3rd USTCF 5-YEAR REVIEW SUMMARY

USTCF Claim No.: 3672
Claimant Name: John Wolf
Site Name: San Paso Truck and Auto
Site Address: 81 Wellsona Road
City: Paso Robles, CA 93440
LOP: San Luis Obispo County
Regional Board: Central Coast (Region 3)

- D. Groundwater Concentration Trends:** Groundwater contaminant concentration trends from monitoring well MW-4 are presented below.

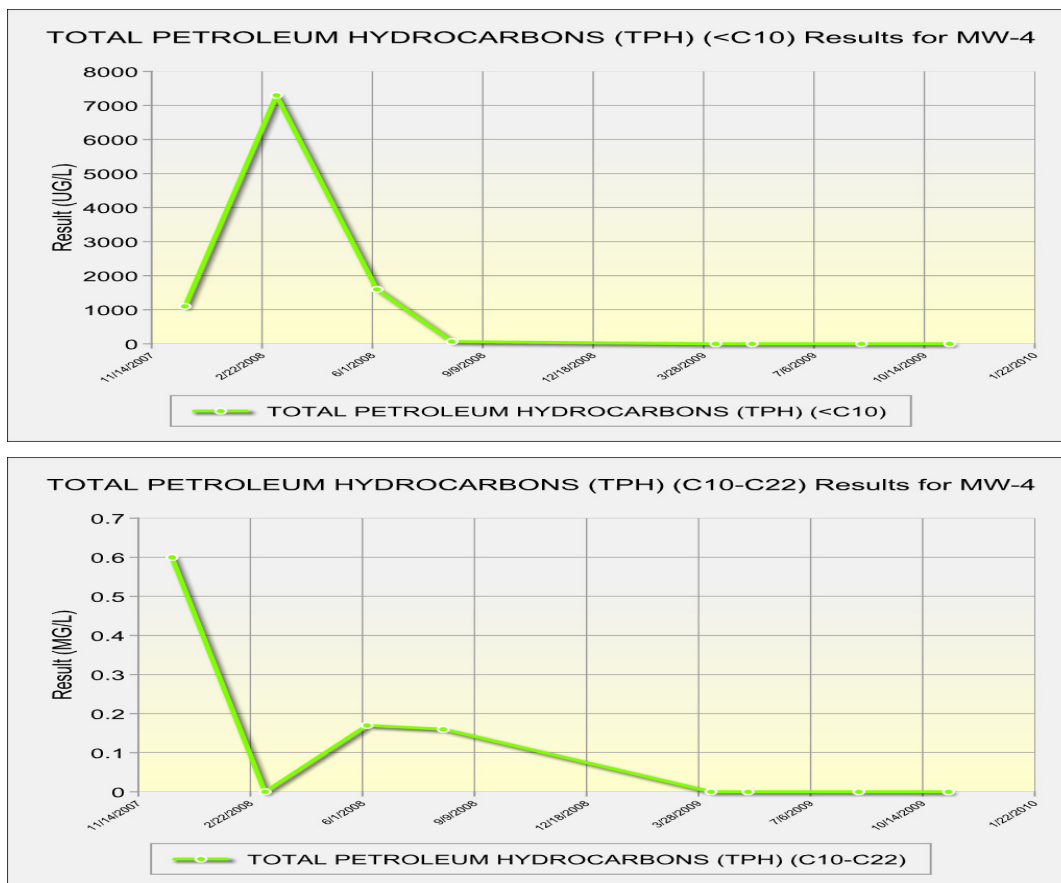
- The responsible party (RP) injected hydrogen peroxide into what would appear to be the up gradient location of the plume if the westerly groundwater flow⁶ direction is correct. As cited above, this does not prove that remedial technology is working only that contaminant concentration at the injection wells is being reduced. Depending upon groundwater flow direction, a well or series of wells may need to be installed to verify that the contaminant plume concentration has being reduced.
